MAINTENANCE INFORMATION Mi07-09

DATE: OCTOBER 2007	SECTION: 16 - Suspension
SUBJECT: RADIUS ROD SUPPORT NEW TIGHTENING TORQUE

FIGURE 1: H3 VEHICLES I-BEAM FRONT AXLE

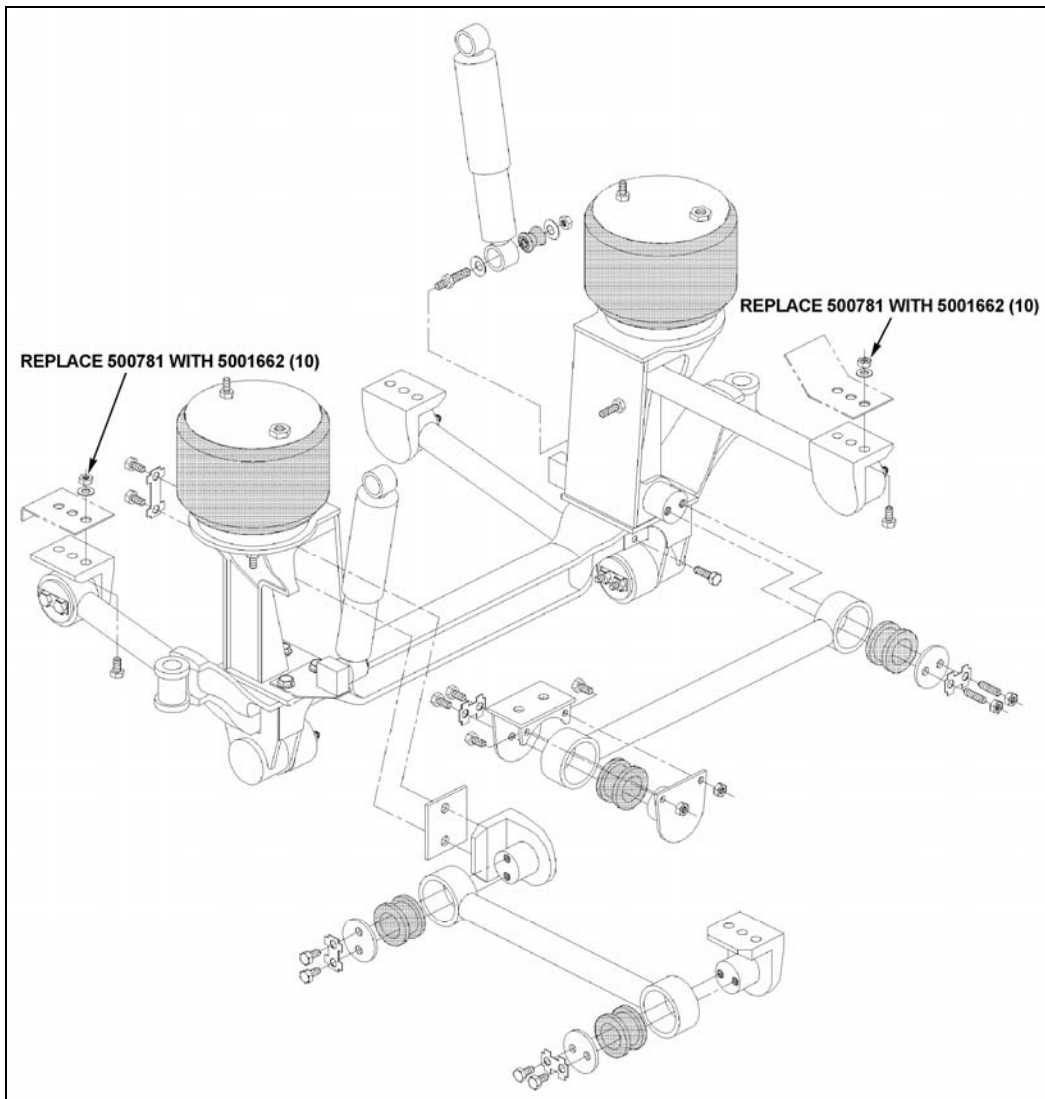
On the above-mentioned vehicles, radius rod support tightening torque was changed from 185 lbf-ft to 225 lbf-ft (250 Nm to 305 Nm). Hex. Stover nut M16-20 part #500781 must be replaced with hex. nylon insert nut M16-20 part #5001662.

1. Raise the vehicle using the frame jacking points.
2. Locate each nut to be replaced (Refer to figures 1 to 7).
3. Replace each nut one at a time to avoid readjustment or alignment.
4. Torque nut to 225 lbf-ft (305 Nm) (dry) then apply corrosion preventing oil (680064).
